ADDENDUM NO. 2

TOWER ROAD BRIDGE AT ROCK CREEK PROJECT

Project No. 1801

For the Department of Public Works, Cowlitz County, Washington

BID SET
 SHEET **S01**
 33 OF 70

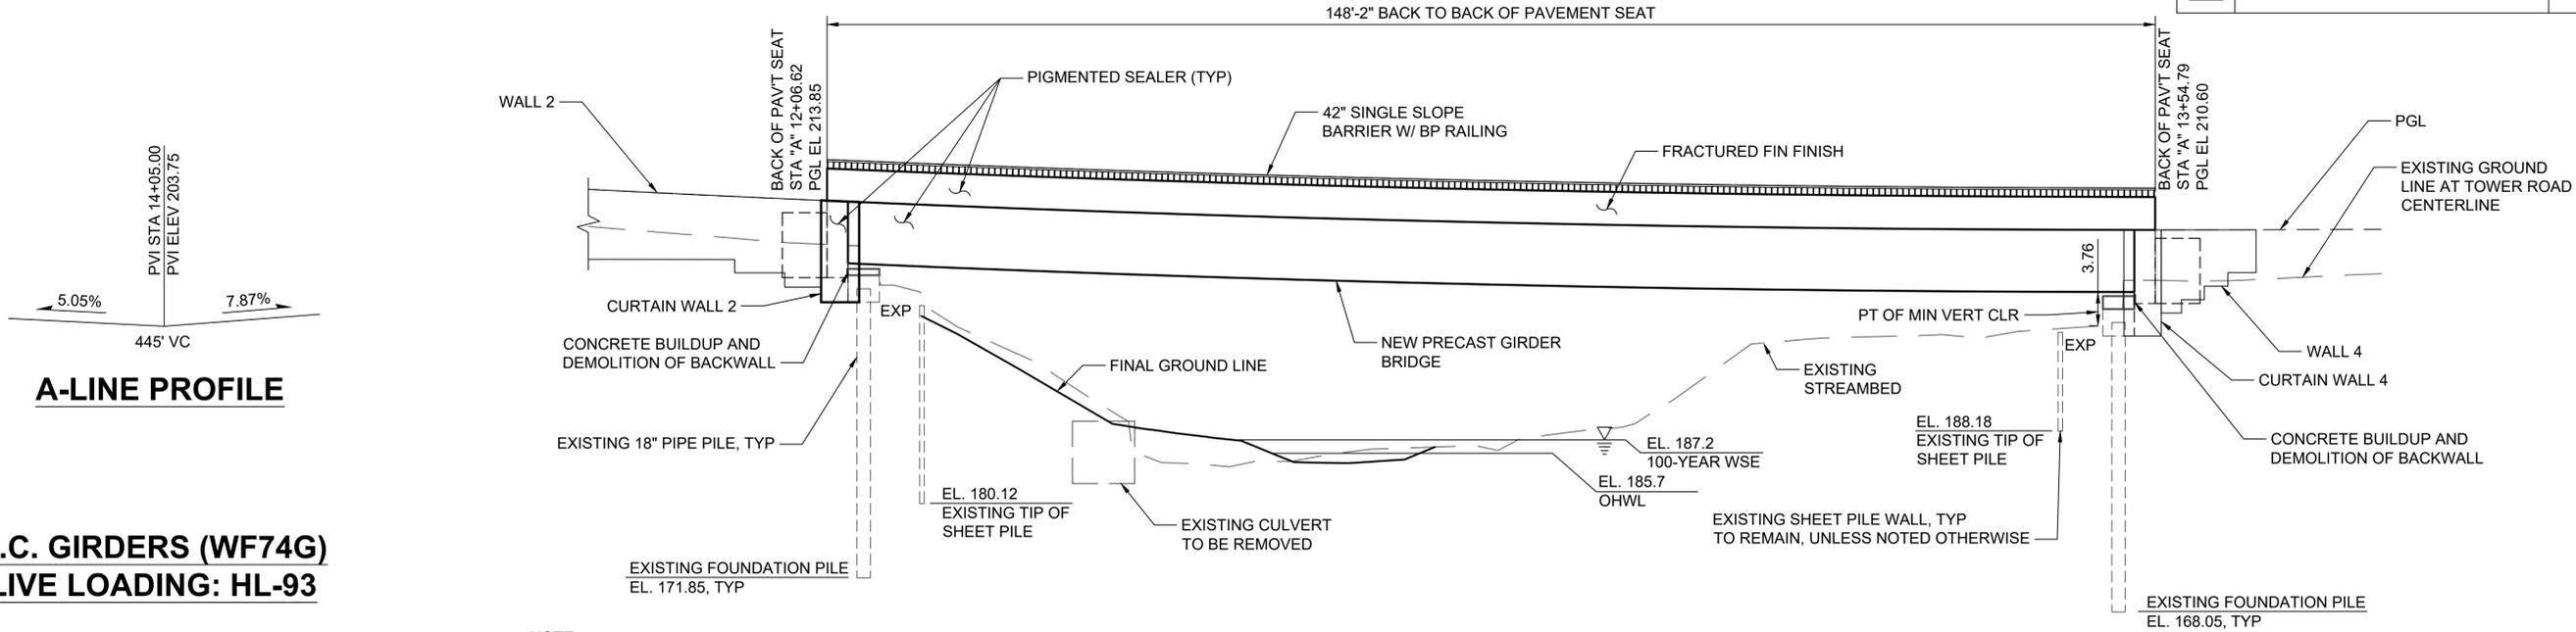
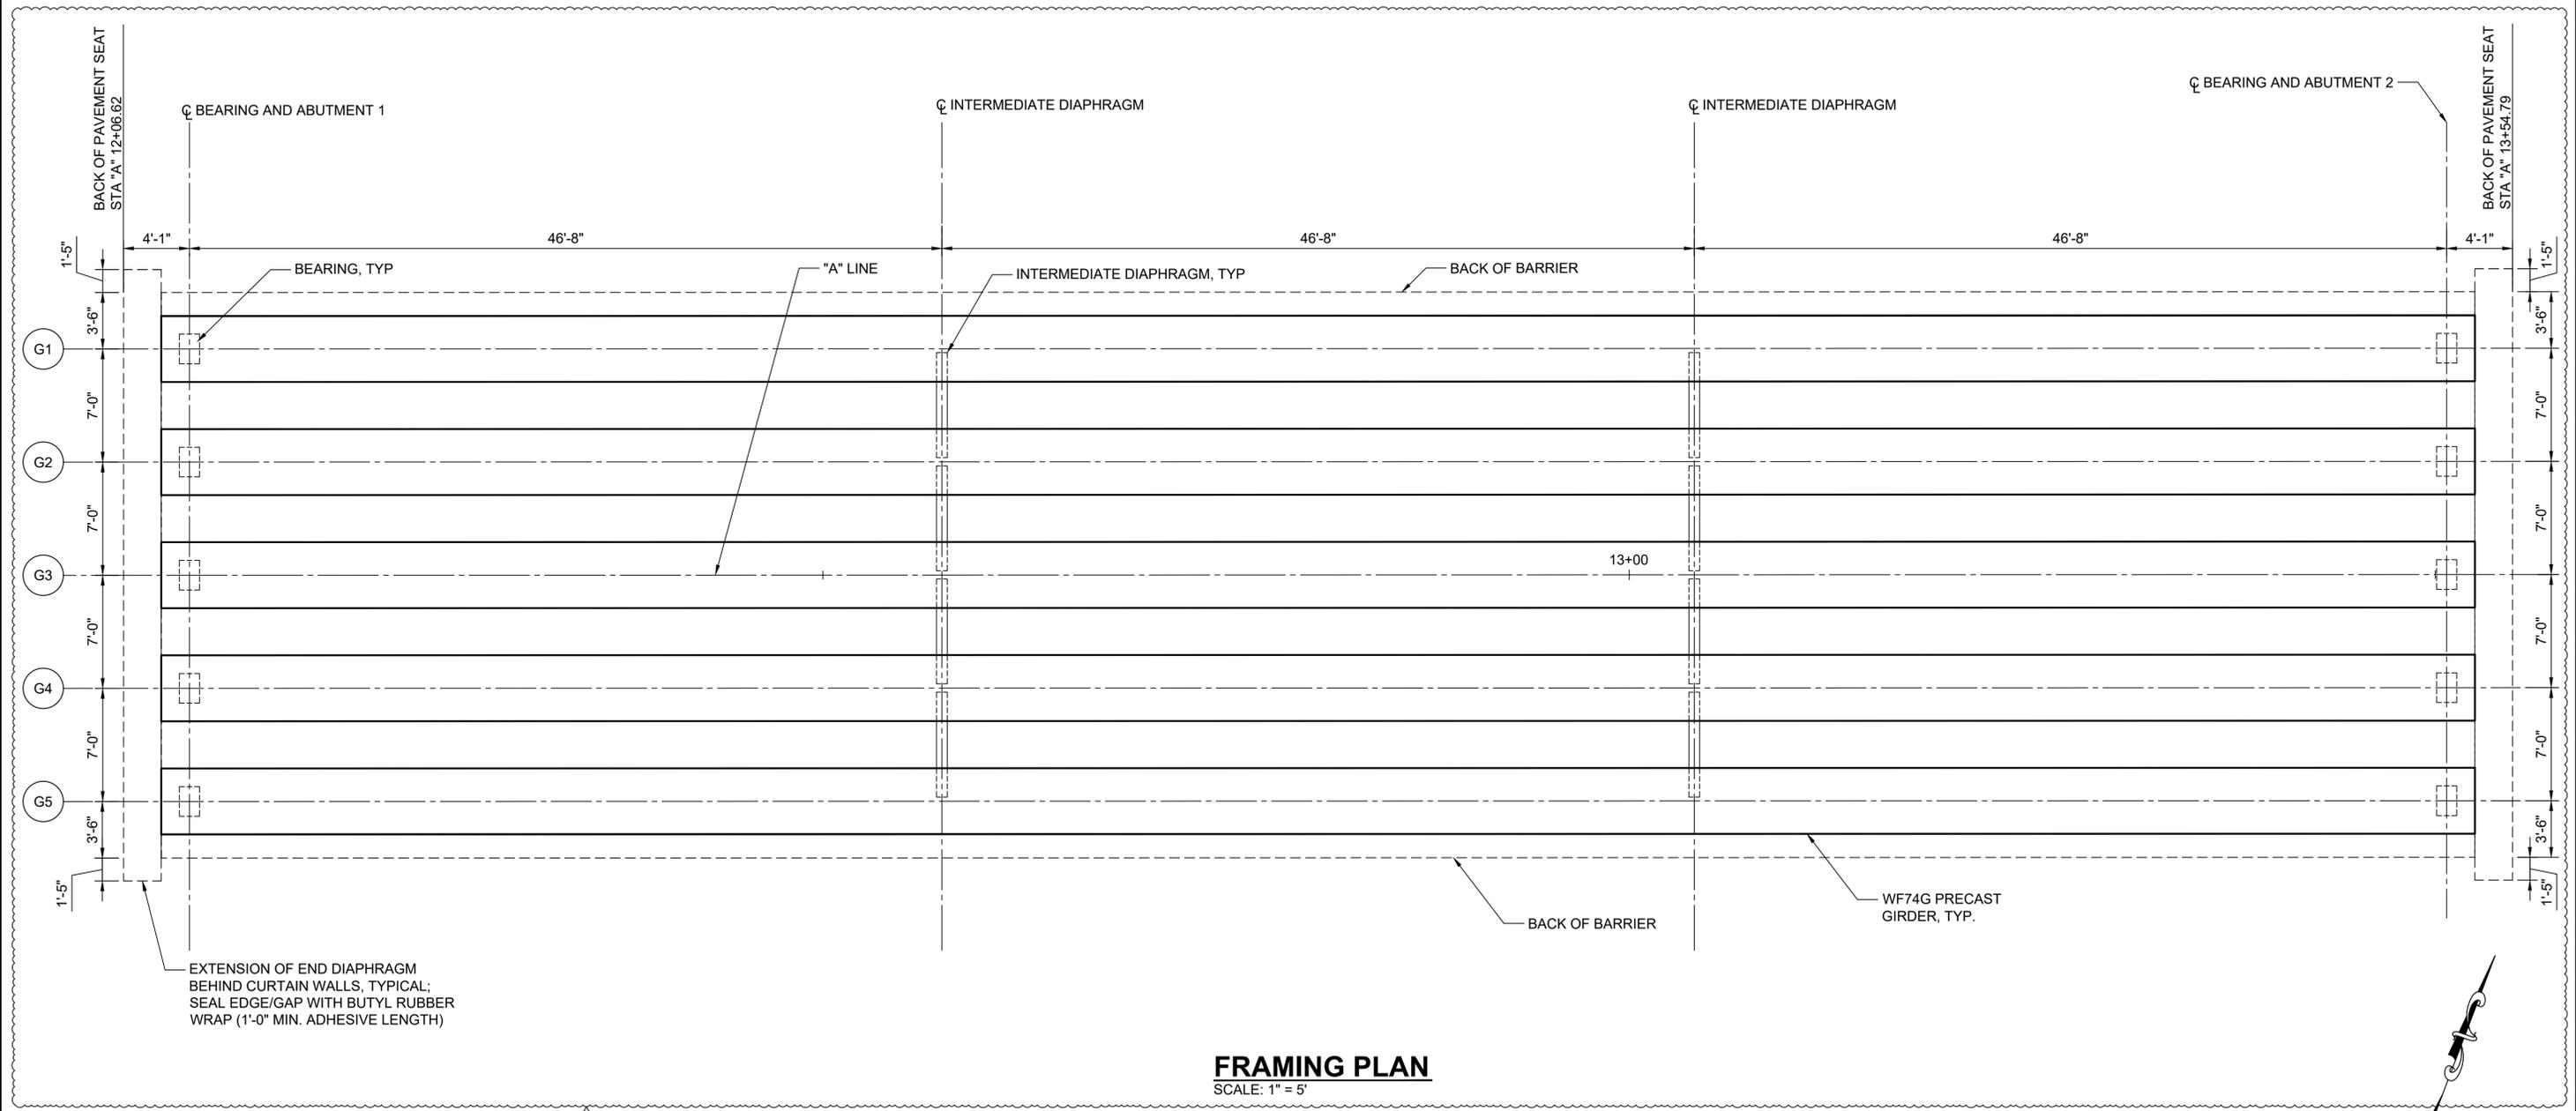
Several structural revisions have been made.

MARK	REVISION DESCRIPTION	BY	APP.	DATE
1	STRUCTURAL UPDATES	KLB	SCB	2/27/2026
